Variance Request Form

Ocotillo Express Wind LLC
 Pier 1 Bay 3
 San Francisco CA 94111
 415-283-4000

Variance: 006
 Request No.: Rev 0
 Date Submit: 7/03/2012
 Date Approval Needed: 7/6/2012
 Date Agency Received: _____
 Agency Approval Reference No.: _____

OCOTILLO WIND PROJECT: IMPERIAL COUNTY, CALIFORNIA VARIANCE 6 - JULY 2, 2012

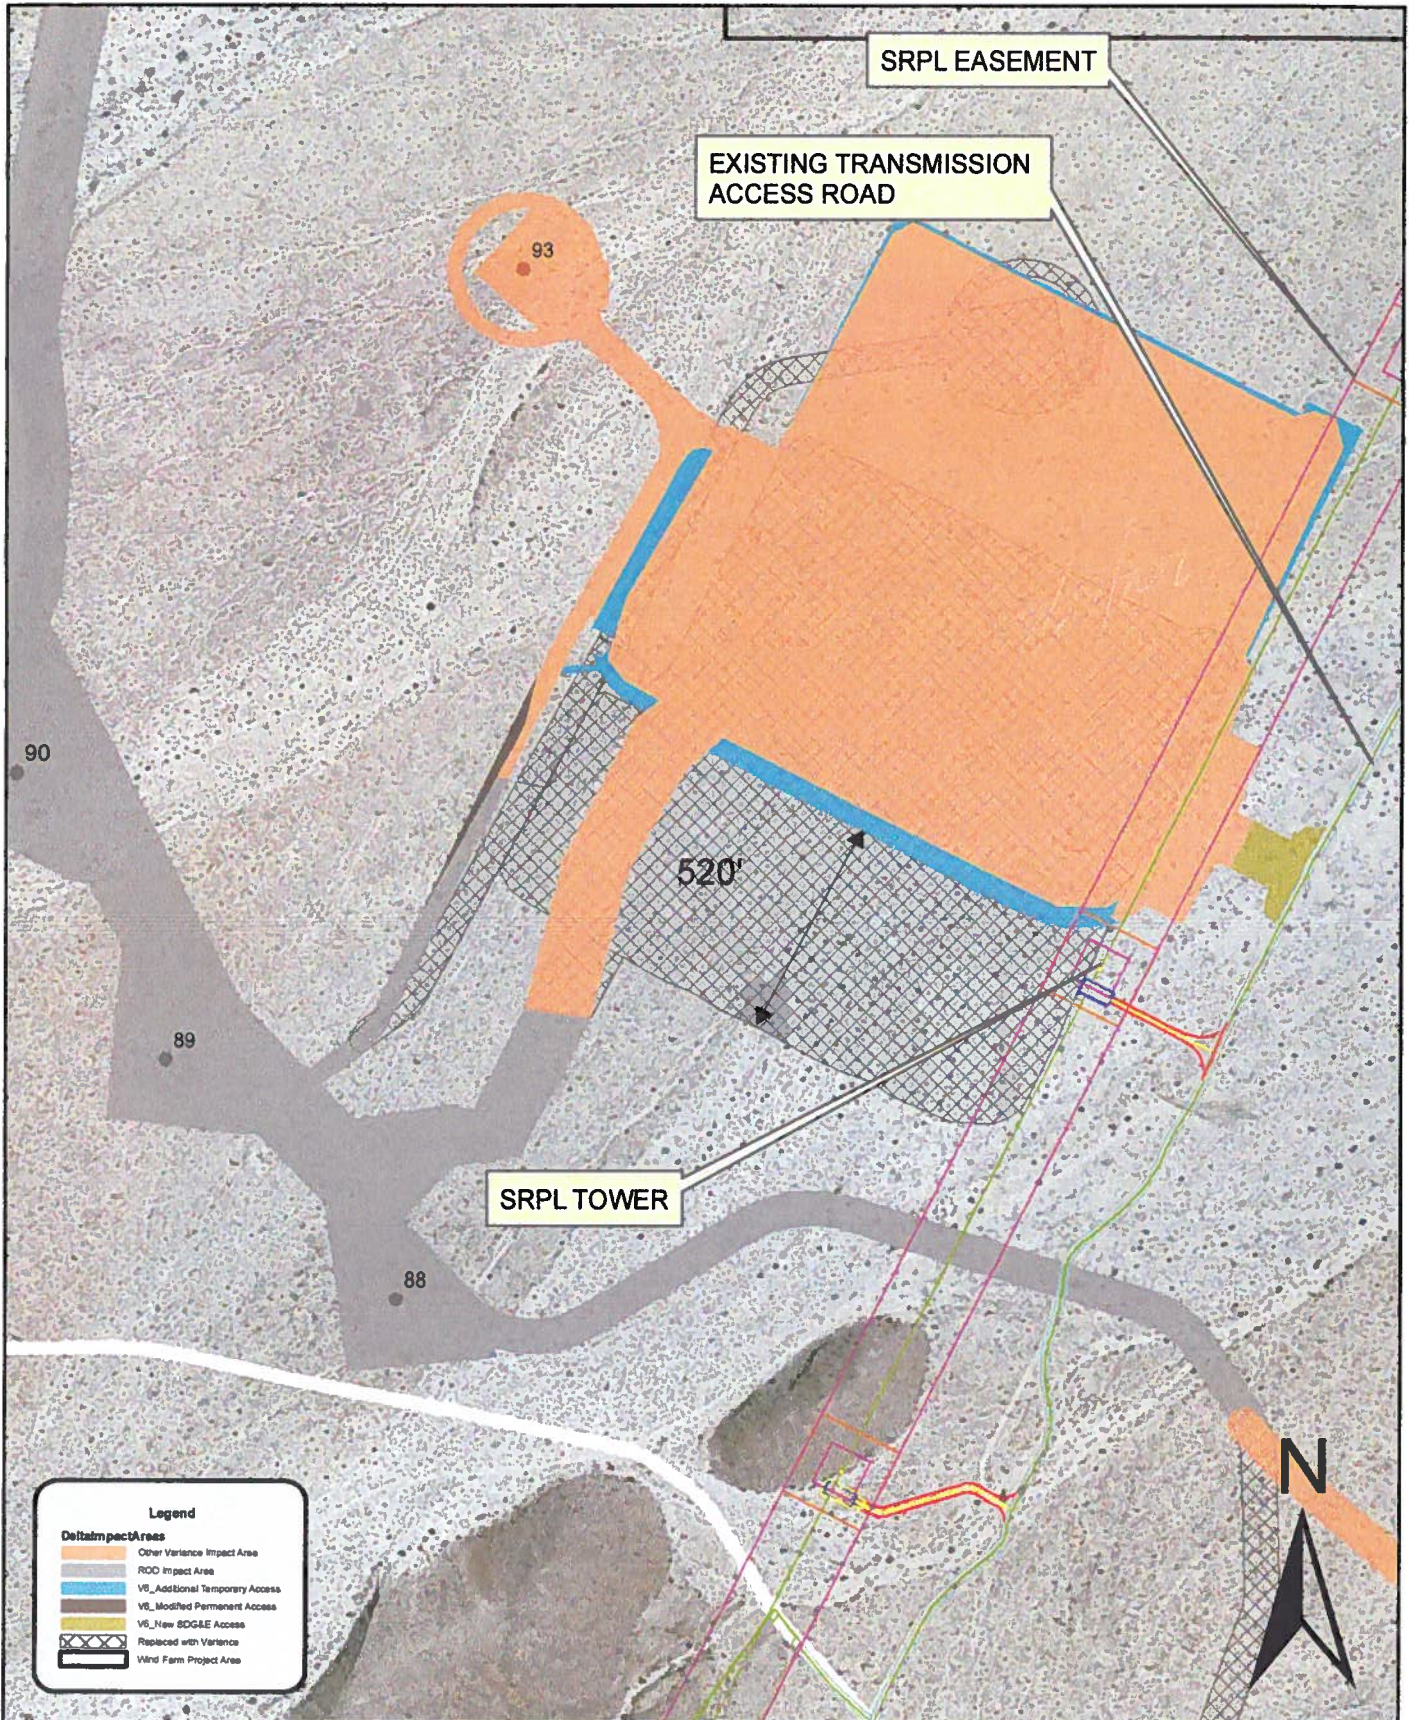
This variance is a result of detailed engineering at the substation/switchyard and includes modified permanent access, additional temporary work space for construction and permanent access to the transmission line turning structures. Specifically, two permanent access components are proposed that include improvements associated with an access road to Turbine 93 to maintain the required width for future operation and maintenance activities and a permanent access road from the eastern limits of the substation to the Sunrise Powerlink access road (see variance request exhibit). The proposed permanent access road to the Sunrise Powerlink access road is being proposed to provide access to turning structures that will provide interconnection from the OWEF substation to the Sunrise Powerlink. Temporary access is also being proposed along the southern, western and northern portions of the substation to complete construction activities associated with constructing the berm along the substation limits. The proposed changes are shown in the attached maps. The SDG&E access area represents a refinement in the SRPL Turning Structure area approved in Variance 001. Variance 006 will result in a permanent disturbance area of 0.74 acres and 2.4 acres in temporary disturbance area.

In accordance with the procedures and guidance provided in the ECCMP, OE LLC is requesting a level 2 variance to modify permanent access and provide additional temporary work space for construction and permanent access to the transmission line turning structures associated with the substation/switchyard. The proposed temporary and permanent work spaces are located in areas that have been surveyed previously. Therefore, no additional biological or cultural surveys are required.
